Amendments to the Drawings:

REMARKS

FIG. 4

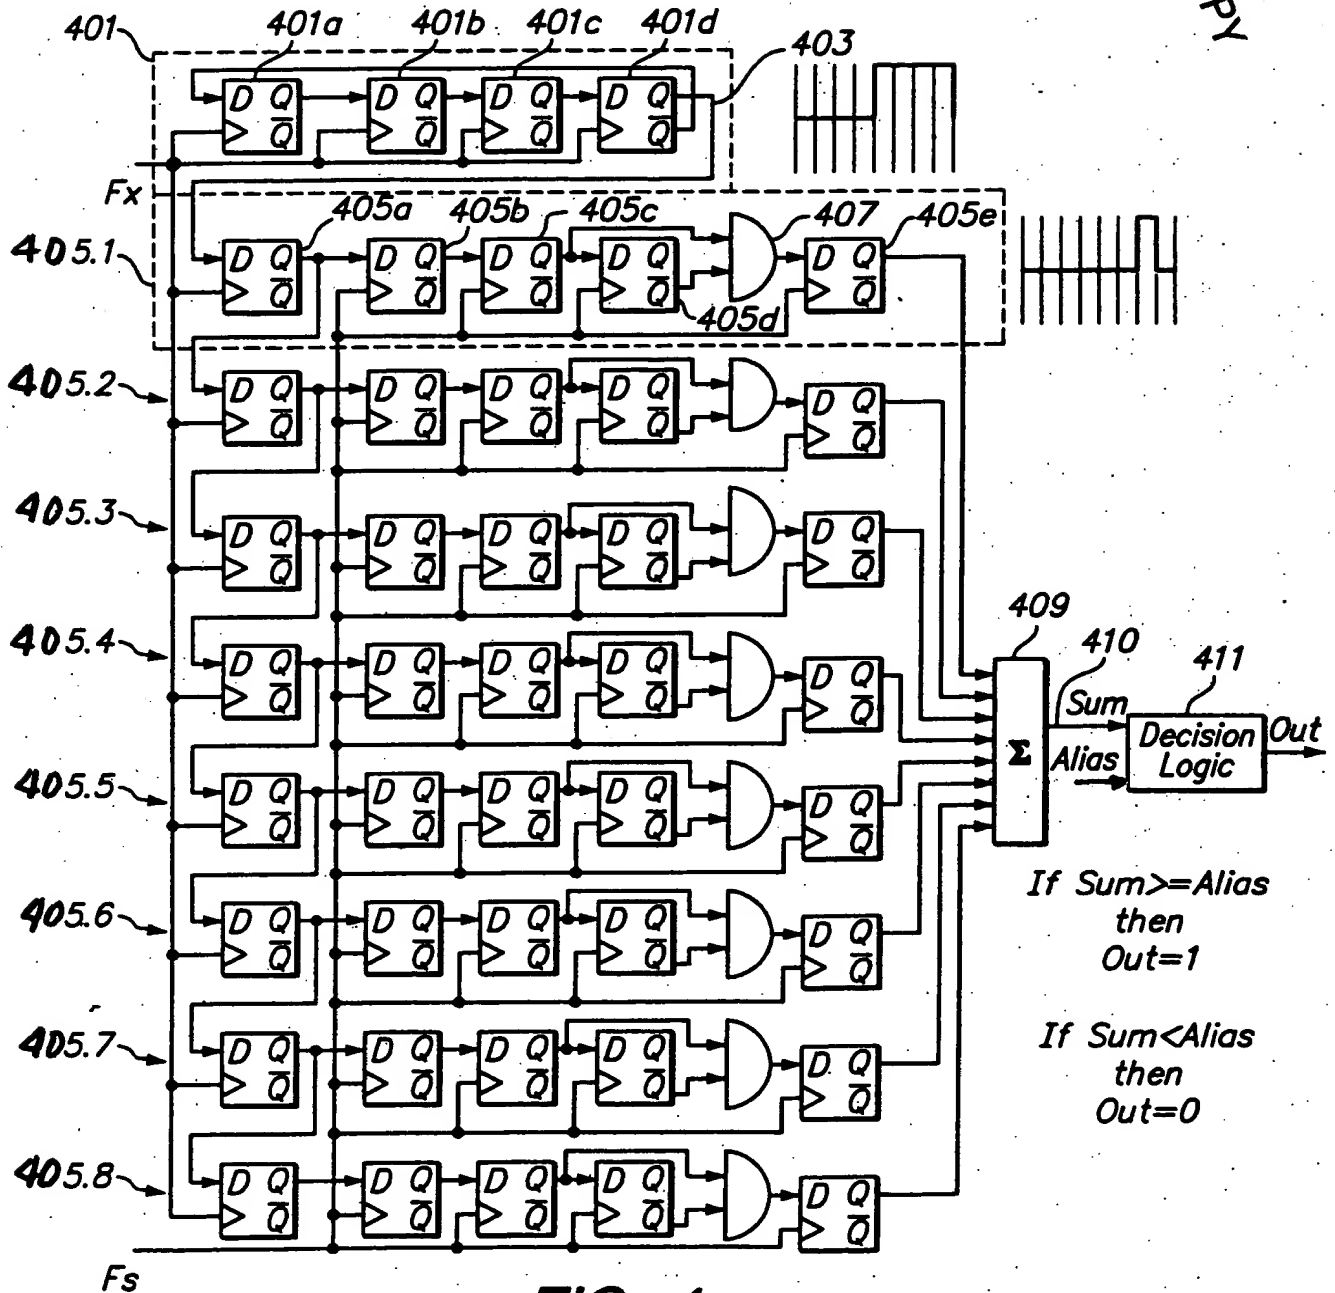
In the May 27, 2005 Office Action, the drawings were objected to for failing to comply with 37 C.F.R. § 1.84(p)(5) for having incorrect reference numerals and for mistakenly showing the “ALIAS” signal as being an output of the summation block 409 in Figure 4 of the drawings. In response, Applicant has amended the Figure 4 of the drawings to correct the mistakes. Applicant requests, therefore, that the drawing objections be withdrawn.

The attached replacement drawing sheet includes amendments to the drawing version of Figure 4 submitted in the January 25, 2005 Amendment. The replacement sheet replaces the previously submitted sheet numbered 3/5. In the corrected drawing, reference numerals “405.1-405.8” are used (as in the originally-filed drawings), rather than the reference numerals “5.1-5.8”, which were mistakenly used in the drawing version of Figure 4 submitted in the January 25, 2005 Amendment. Additionally, the “ALIAS” signal applied to the “Decision Logic” block 411 in Figure 4 has been corrected. The reference numeral amendments and the amendment to the “ALIAS” signal are both in agreement with and consistent with the originally filed patent application. Further, no new matter is entered by the drawing changes. In addition to the replacement sheet, an annotated sheet showing changes in red is attached to this Amendment.
